DESIGN REVIEW BOARD JANUARY 21, 2022

Design Review Board Meeting
November 19, 2021
Department of Community Development
ALPHARETTA CITY HALL | 2 PARK PLAZA
8:30 AM

SHEET NO:
A-5.1

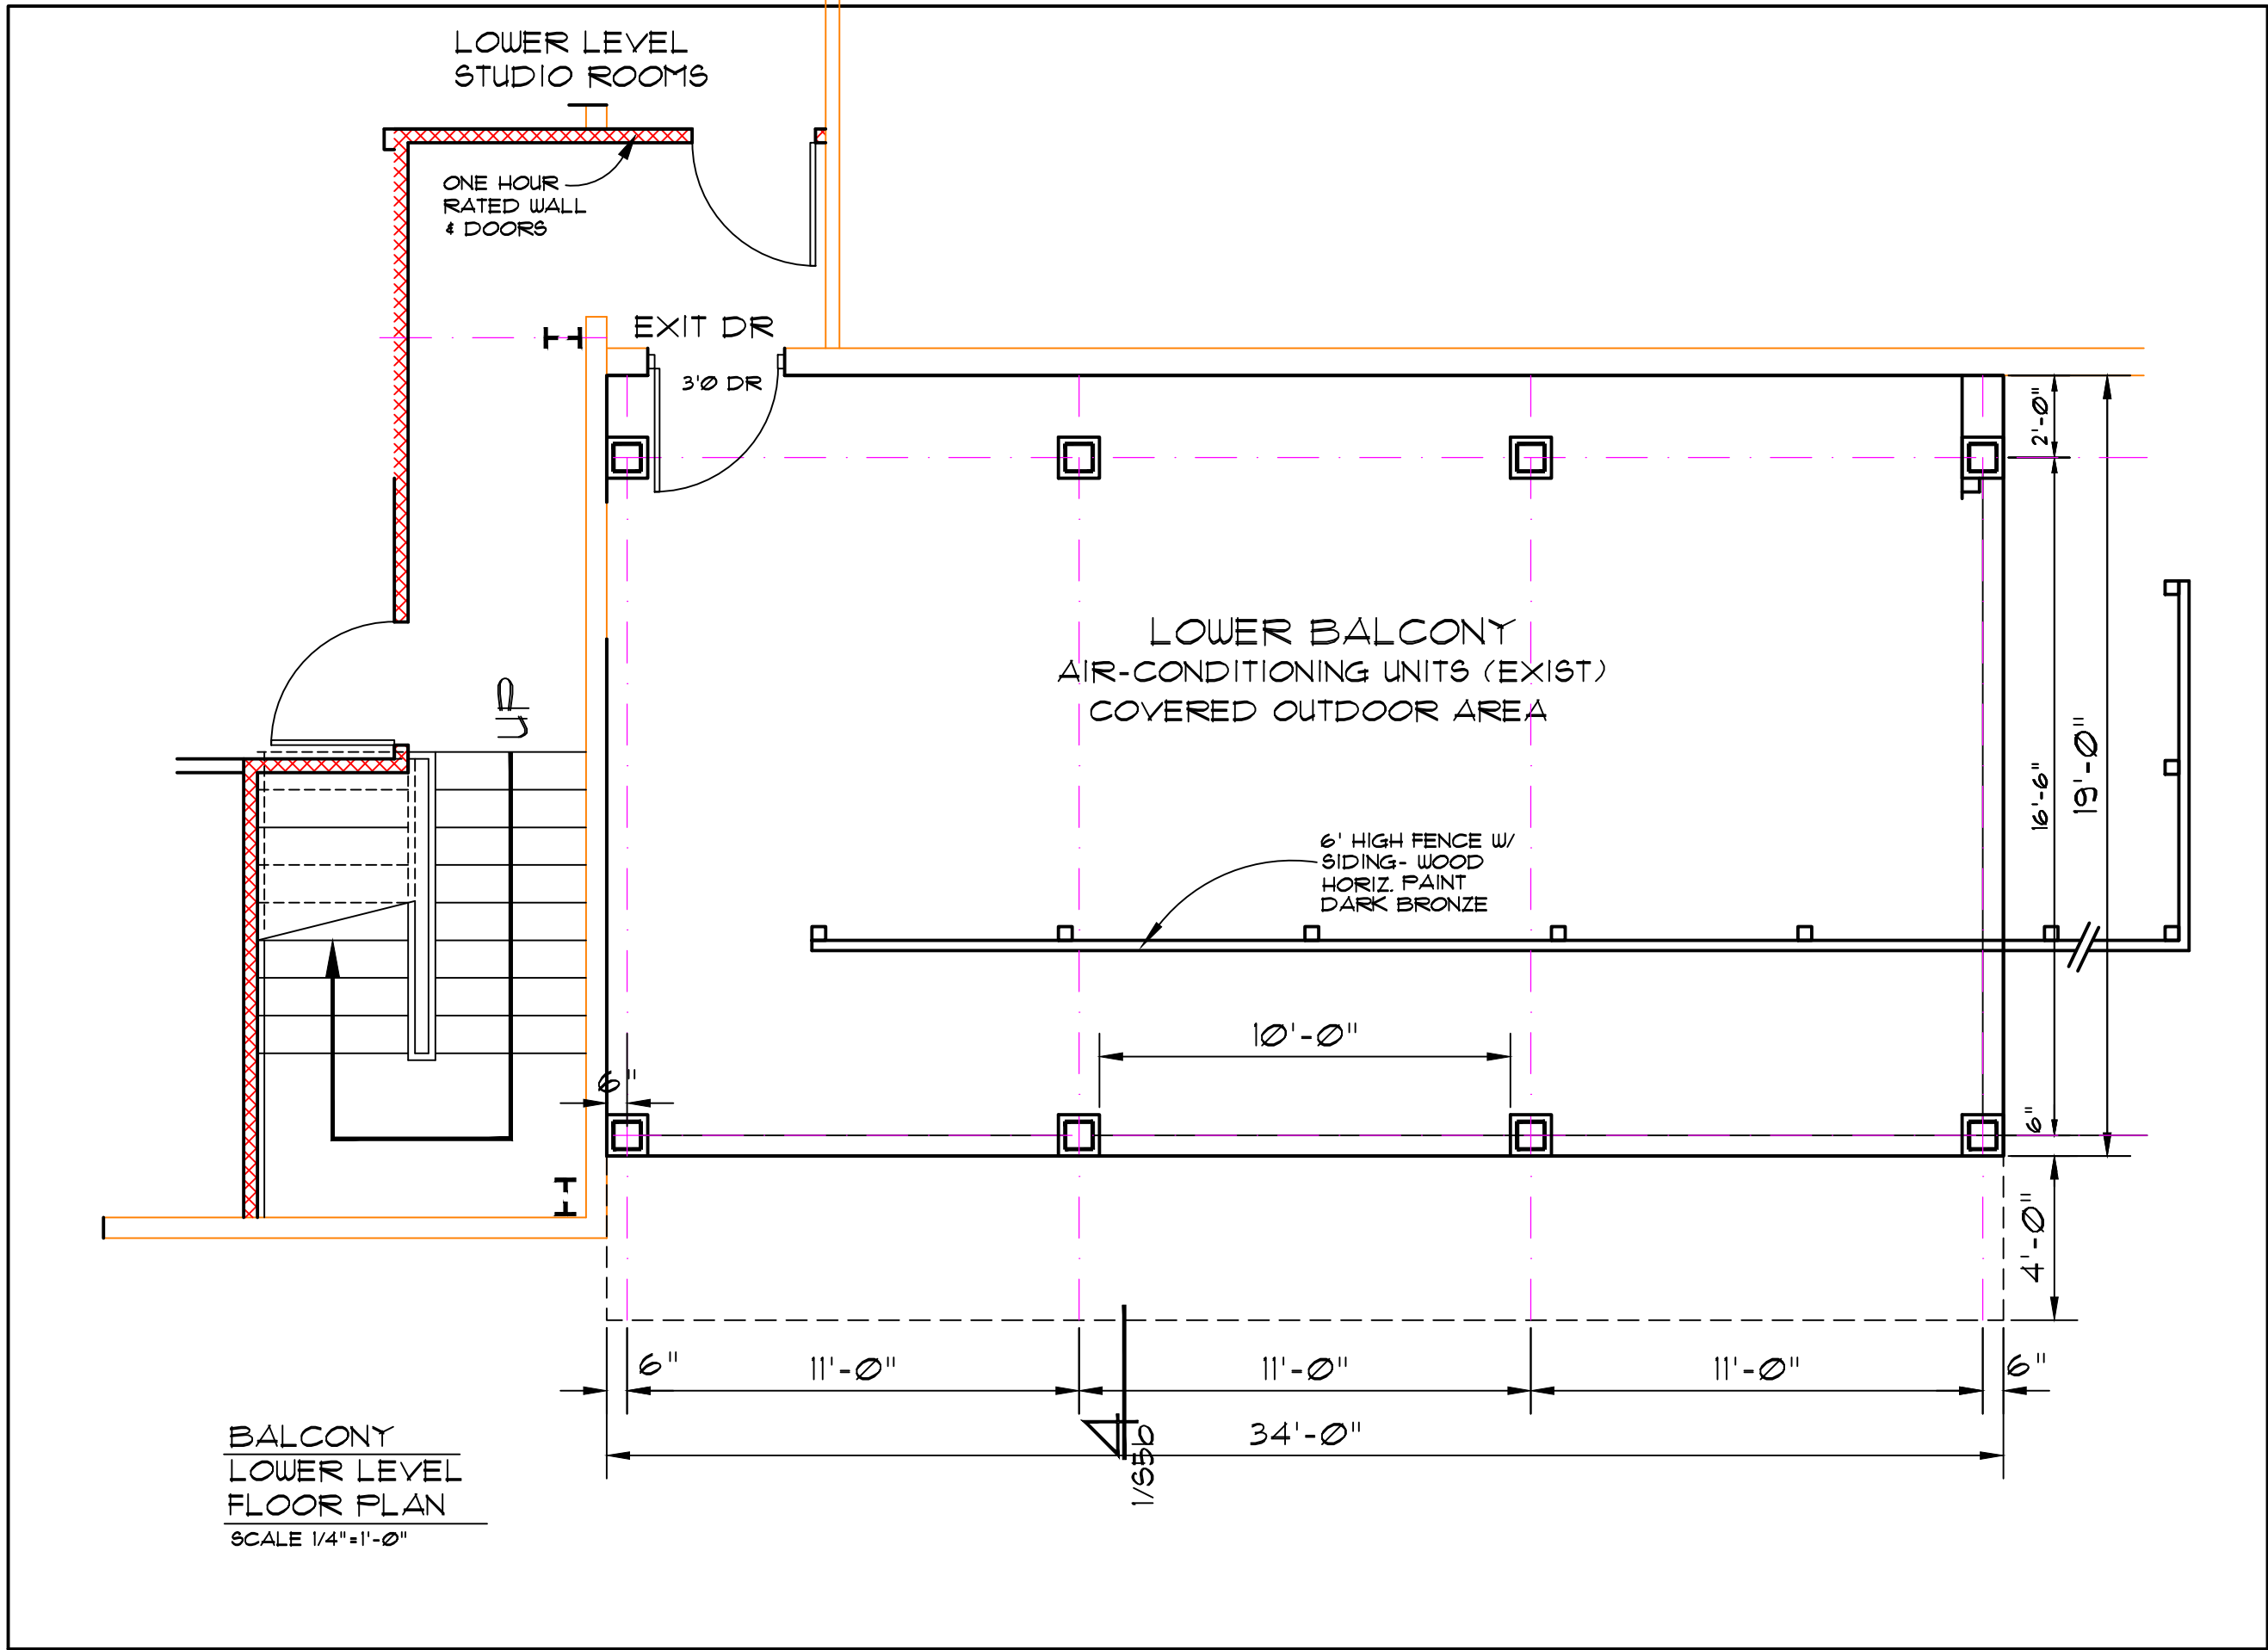
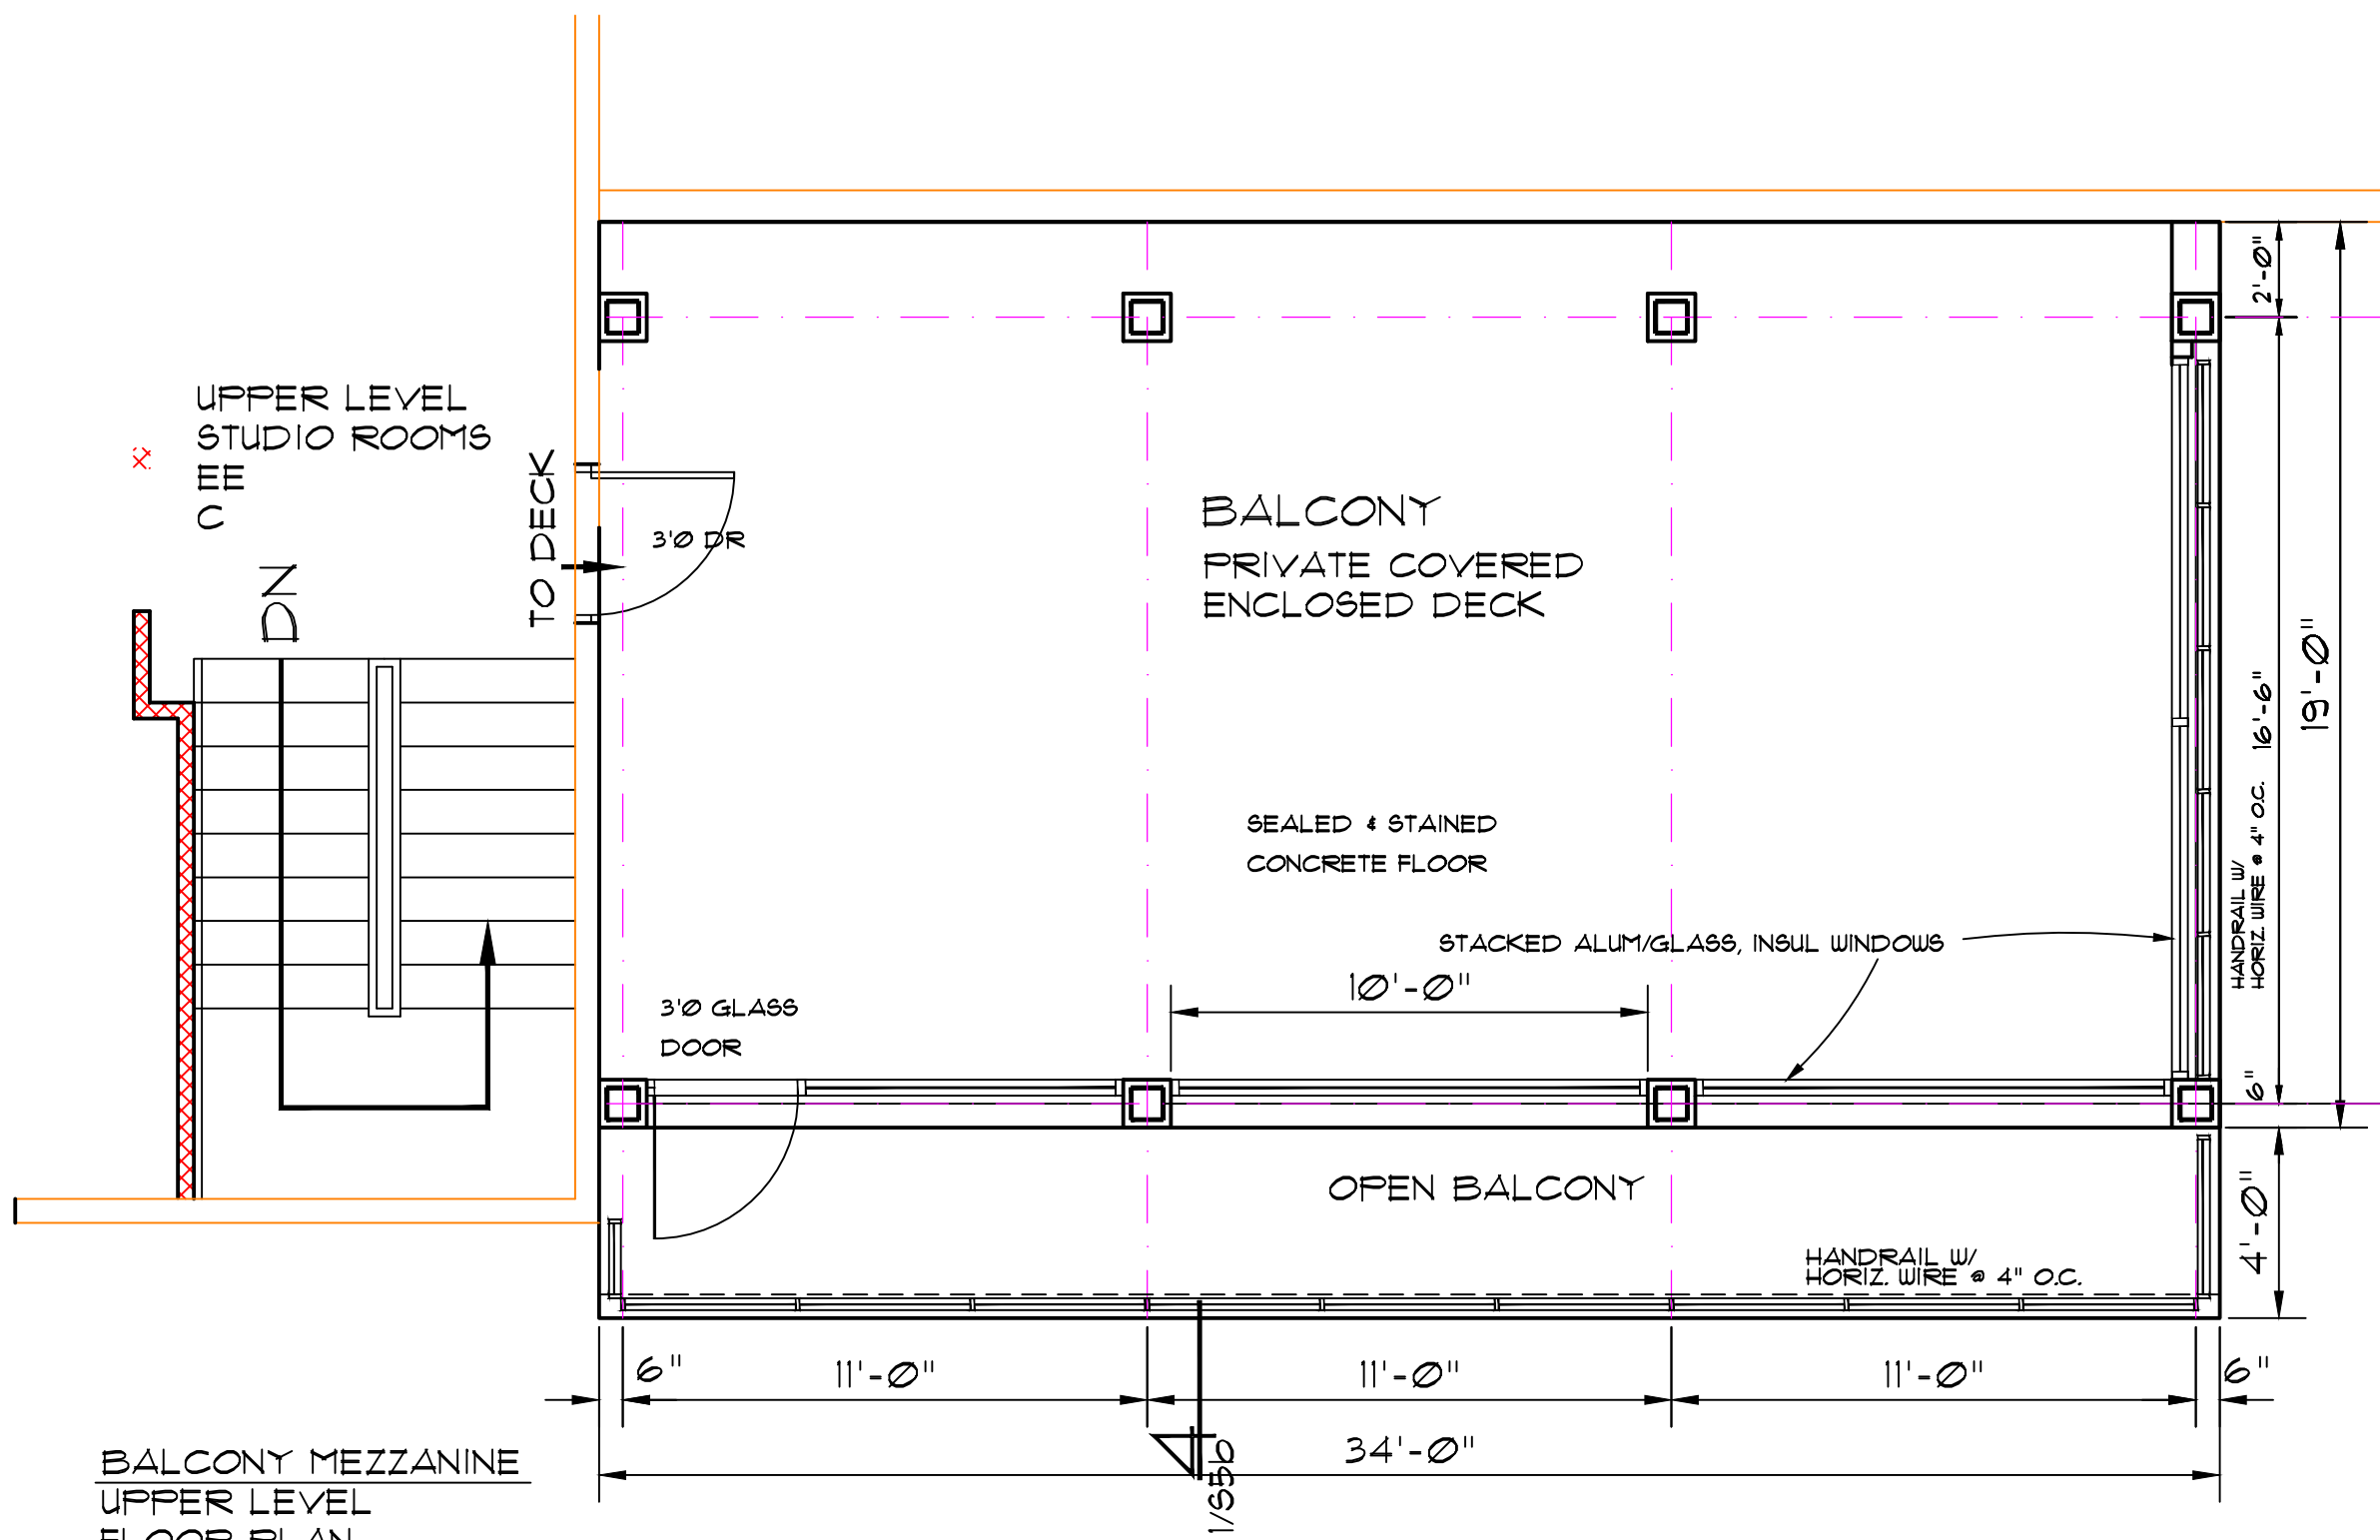
As per your comments we have added a new fascia around the balcony roof with the finish matching the existing building fascia. We have modified the lower level back to the existing conditions keeping the air conditioning units and the fence around (with new finish and Bronze paint). We are painting the frame a bronze color matching the existing frames as shown in the pictures. The windows and handrails are aluminum color matching existing storefronts.
